Central Coast Quarter 26 Mann Street Gosford

RTS RESPONSE PACK

26-32 MANN STREET, GOSFORD

Solar access to key public spaces

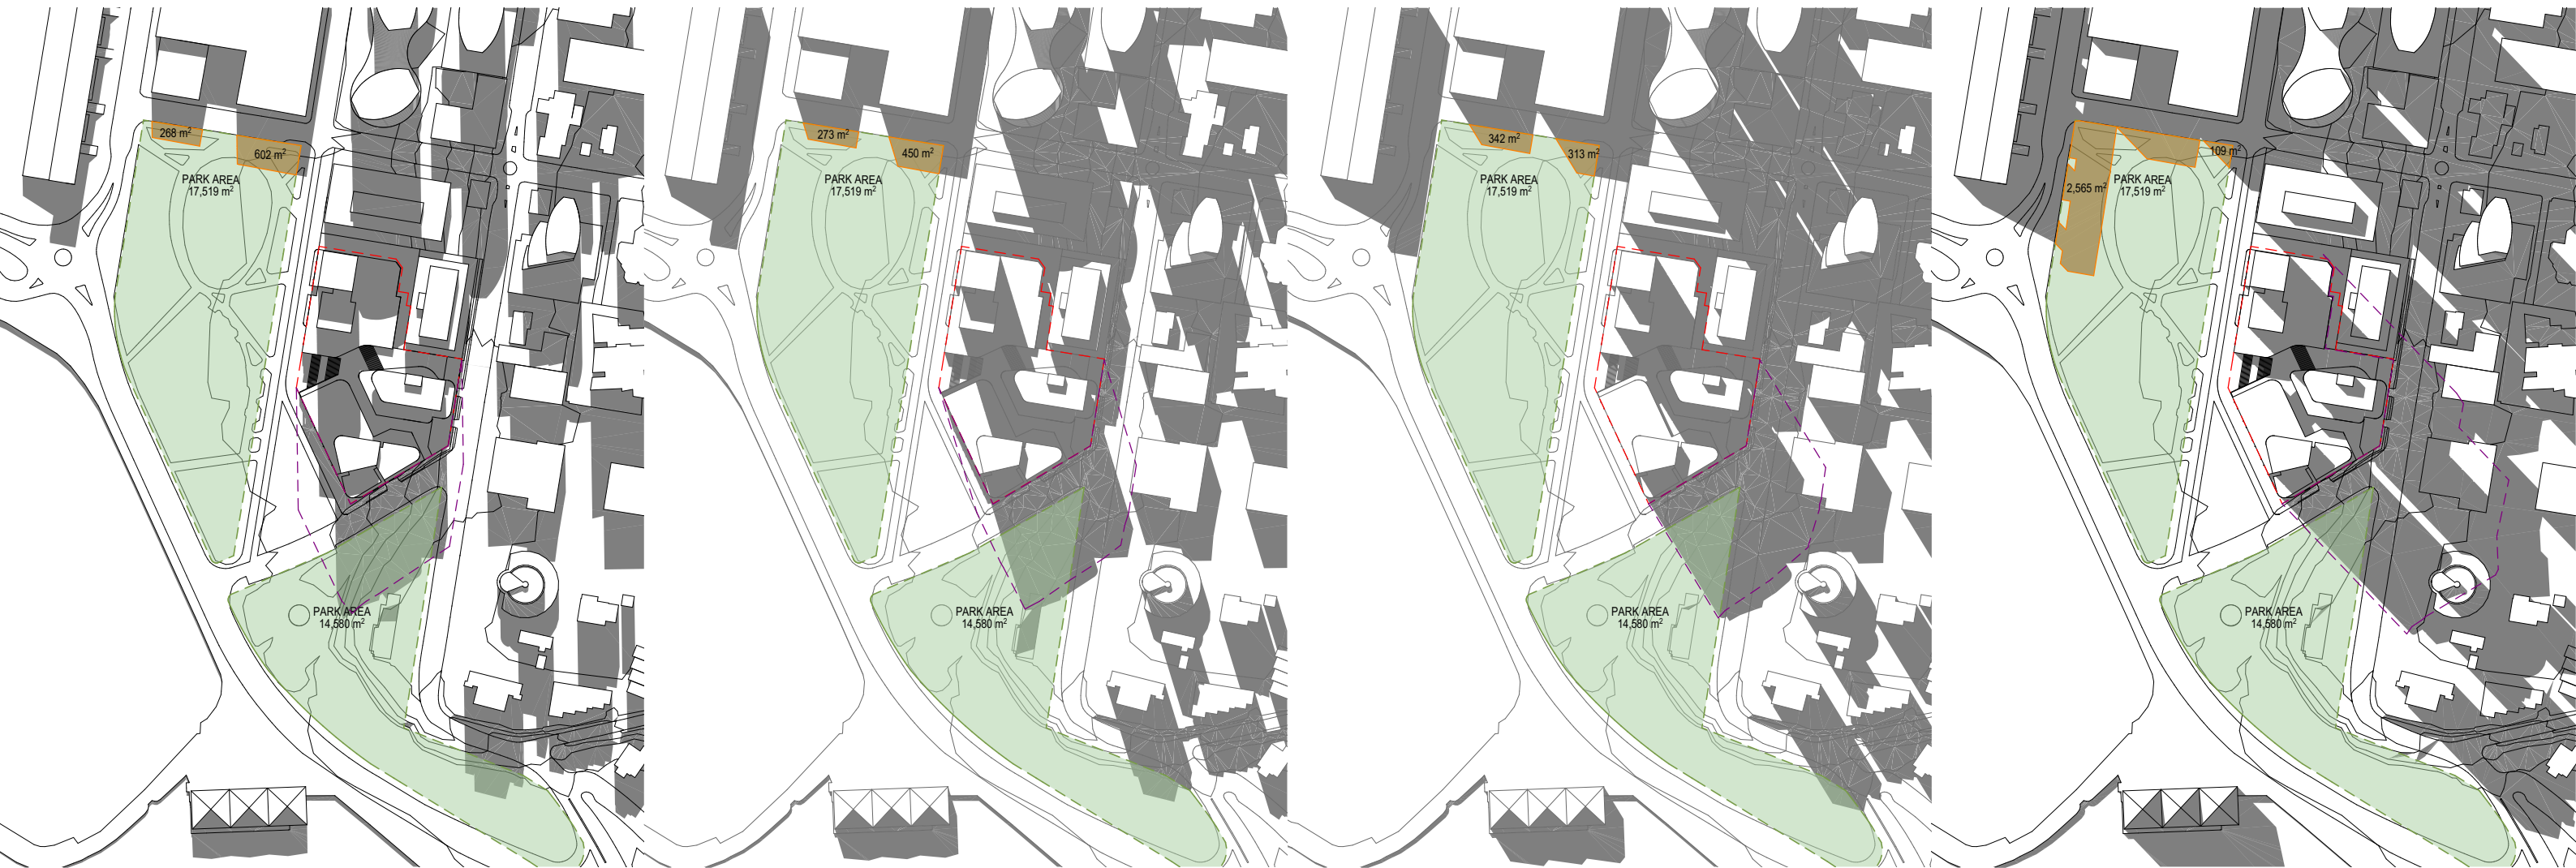
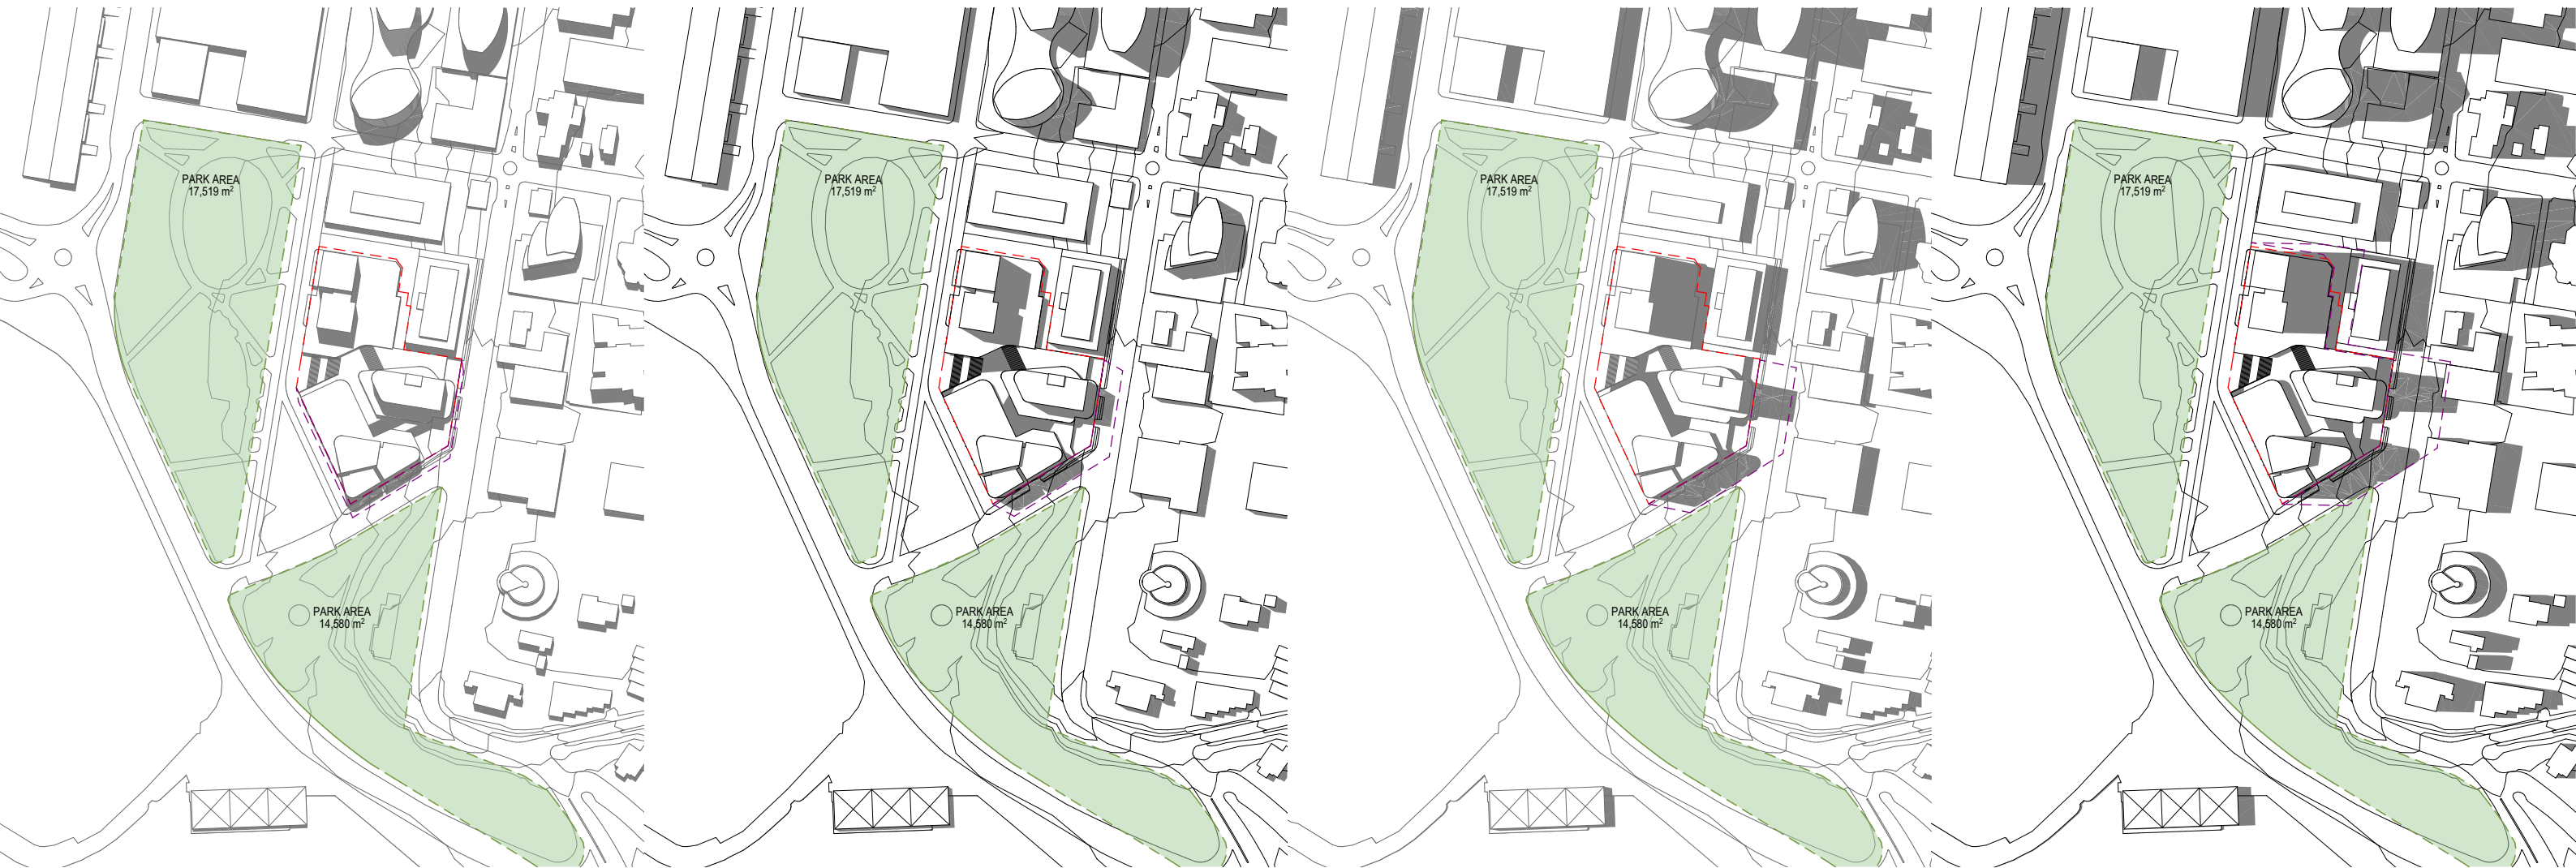
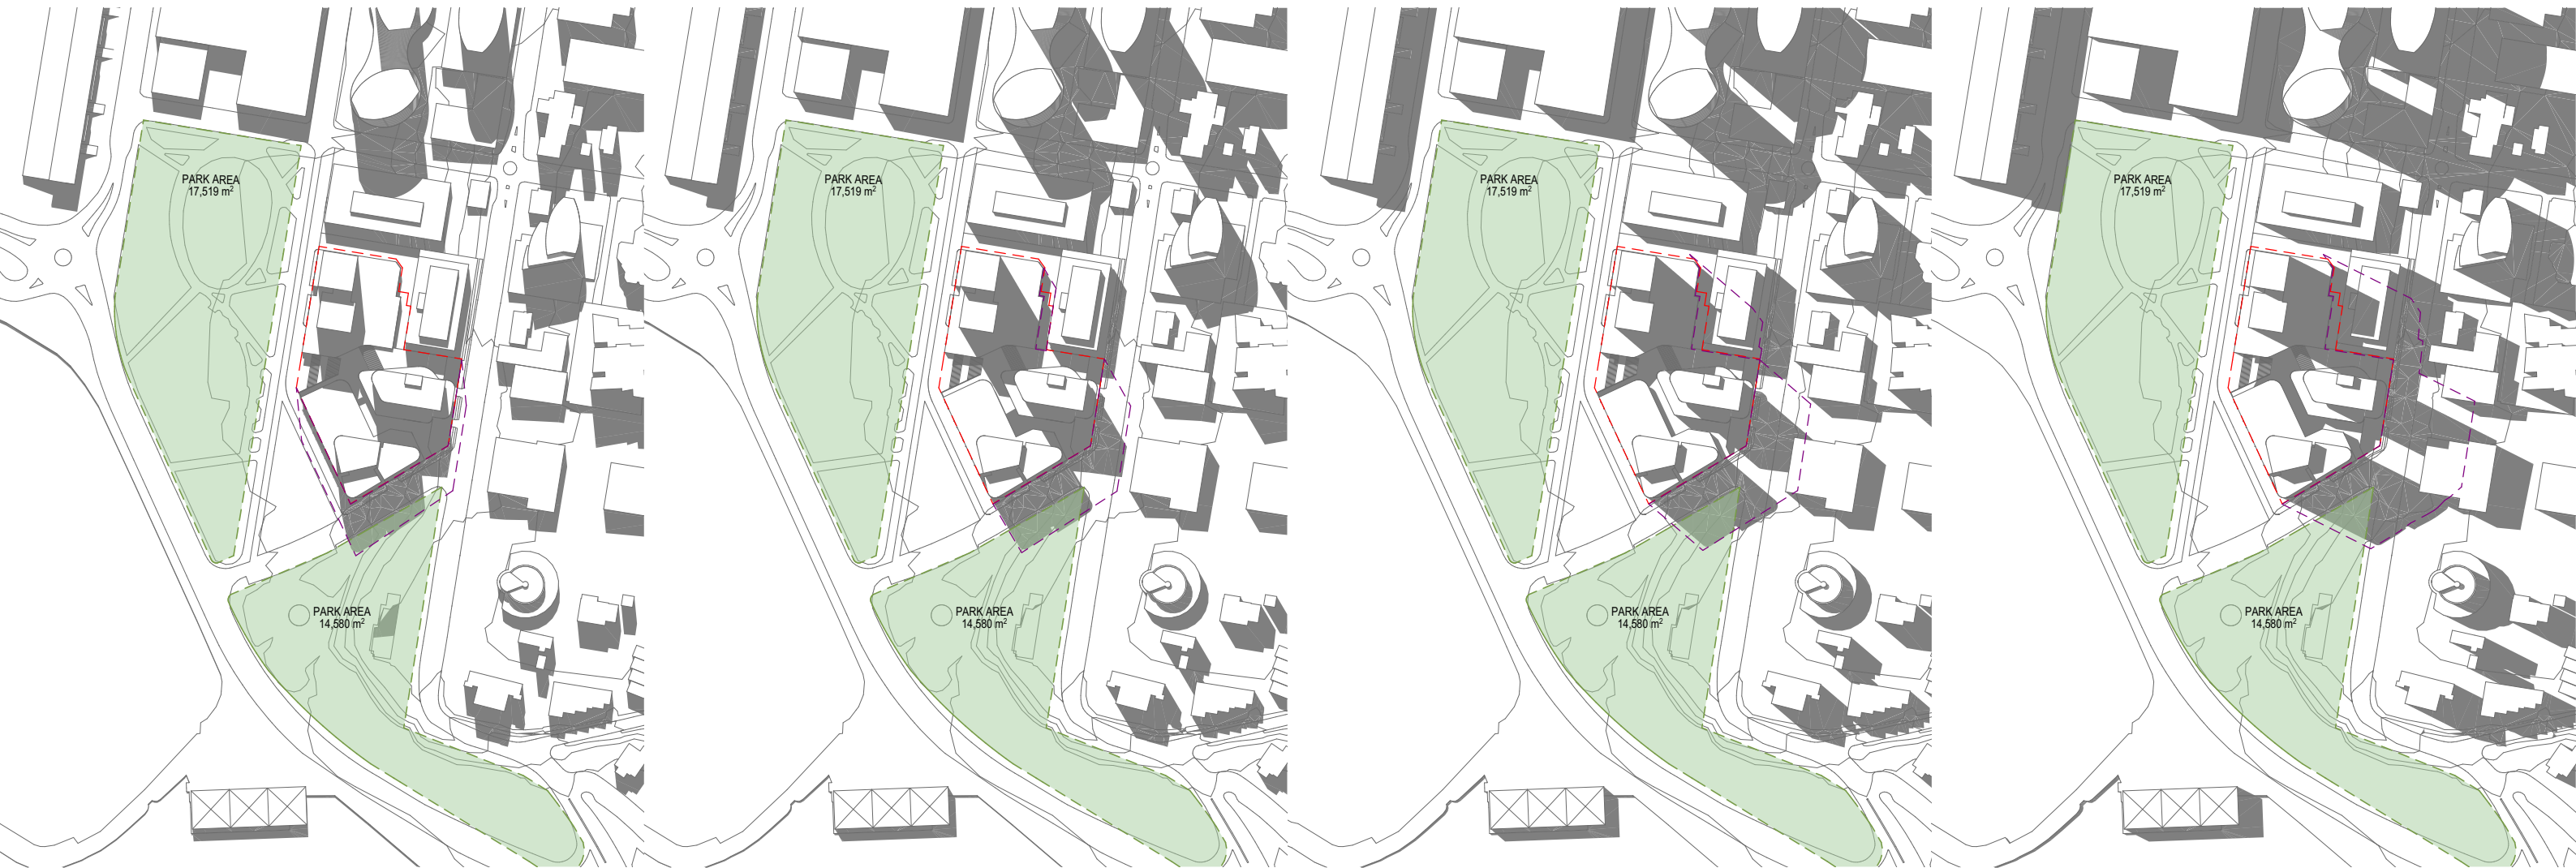
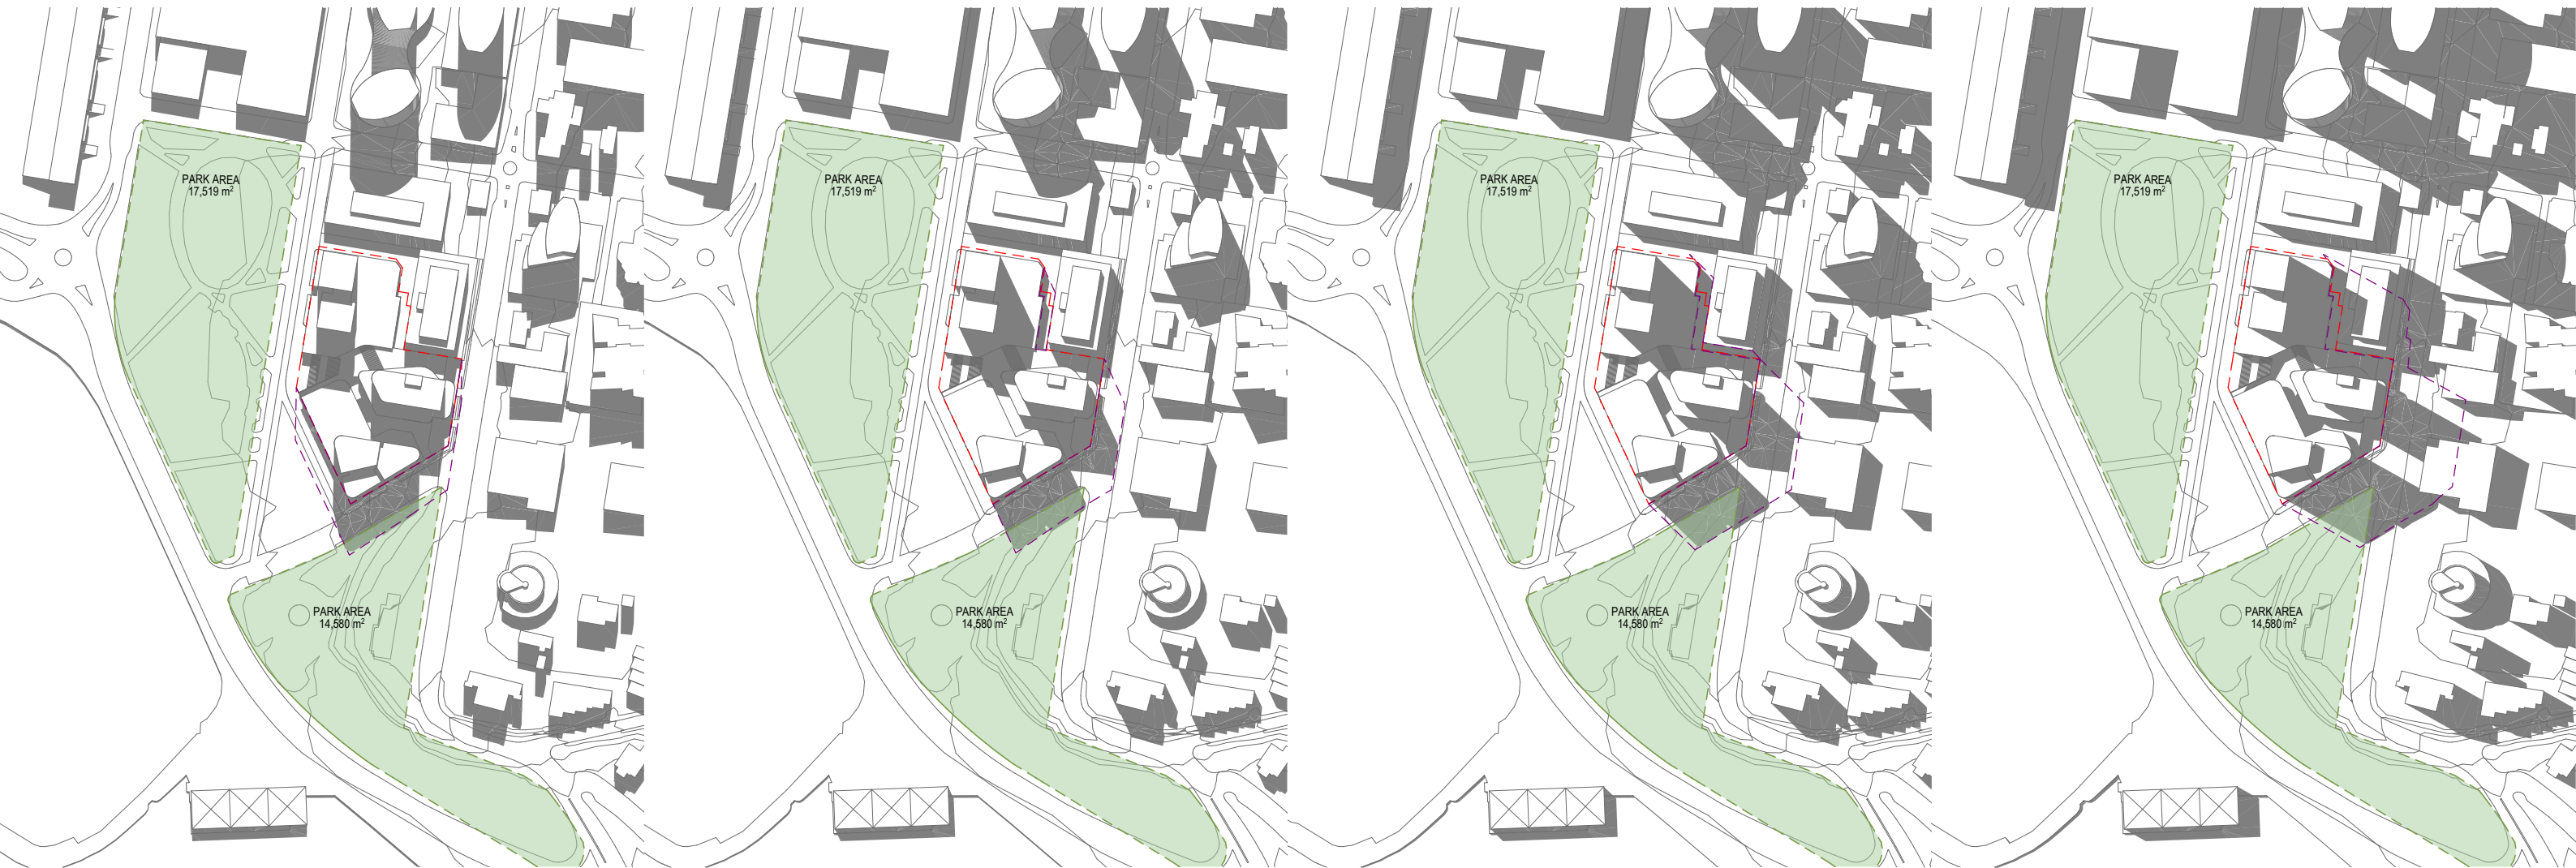
7) Noting Council’s concerns about potential solar and amenity impacts associated with the proposal, the Department requests amended shadow diagrams showing the solar access impacts (for summer and winter solstice and spring and autumn equinox, at hourly intervals between 9am and 3pm) to the surrounding public domain, including Leagues Club Field, Poppy Park, the Memorial Park and the Waterfront and likely solar access to the proposed through site links.

Shadow diagrams have been provided for summer and winter solstice and spring and autumn equinox. 100% of Leagues Club Field receives 4 hours of direct sunlight. Memorial Park and Poppy Park only affected by proposed between 10am and 11am.

In comparison to the proposed scheme, the RL 48 Scheme overshadows the park for an additional 800sqm between the hours of 9-10am (approximately 11% more overshadowing than the proposed scheme)
